DGL GROUP LIMITED
Proposed Liquid Waste Treatment Plant
Flood Risk Management Study
16151 – August 2021

FLOOD RISK MANAGEMENT STUDY

PROPOSED LIQUID WASTE TREATMENT PLANT– UNANDERRA

STATE SIGNIFICANT DEVELOPMENT SSD 8304 – PROPOSED LIQUID WASTE TREATMENT– REQUEST FOR ADVICE

1 % AEP Flood Depths and Spot Flood Levels (m AHD)

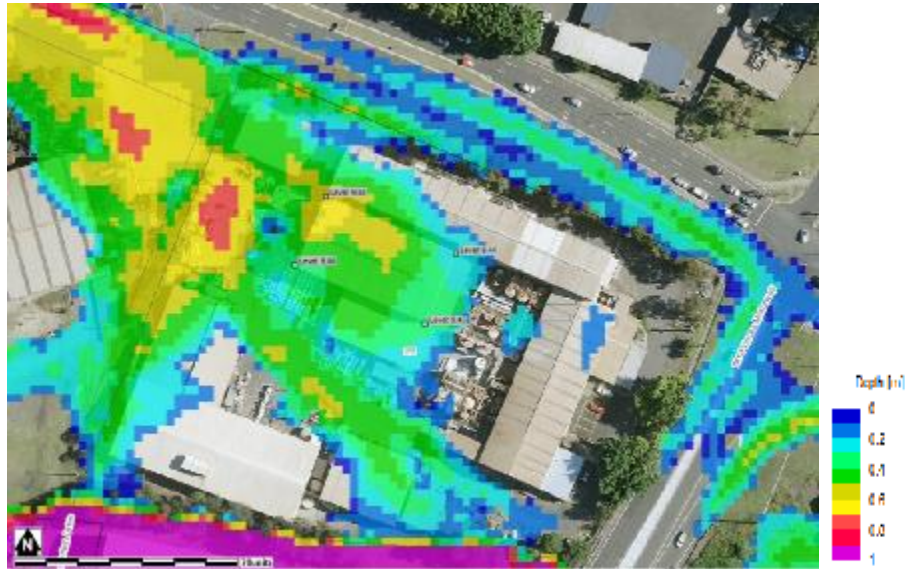
- Council's adopted Allans Creek Flood Study dated 2019 indicates a significant flood flow path through the site flowing adjacent to and around the existing building within which a liquid waste treatment plant is proposed (i.e., 'Building E'), with predicted flood levels and corresponding above floor flood depths in existing Building E being as per the table below.

10 % AEP (10 year ARI)	1 % AEP (100 year ARI)	PMF (Probable Maximum Flood)
Flood Level (m AHD)*	9.53	9.84	10.43
Above Floor Flood Depth (m)**	0.35	0.66	1.25

*The maximum flood level at Building E – predicted by Council's adopted Allans Creek Flood Study dated 2019.

**Above floor flood depth determined using the surveyed finished floor level for Building E (RL 9.18 m AHD) shown on the site survey plans appended to submitted flood risk assessment report by SitePlus.

- Council's adopted Allans Creek Flood Study dated 2019 also maps the location of Building E as a mix of hydraulic hazard category '*H2 – Unsafe for small vehicles*' and '*H3 – Unsafe for all vehicles, children & elderly*'.

- Due to the predicted flood levels, depths, and hazard through the site and within Building E (as above), the development proposal presents significant flood risks, due to potential damage to plant/equipment, machinery, etc., and pollution of the surrounding land in the event of floodwater combining with liquid waste.
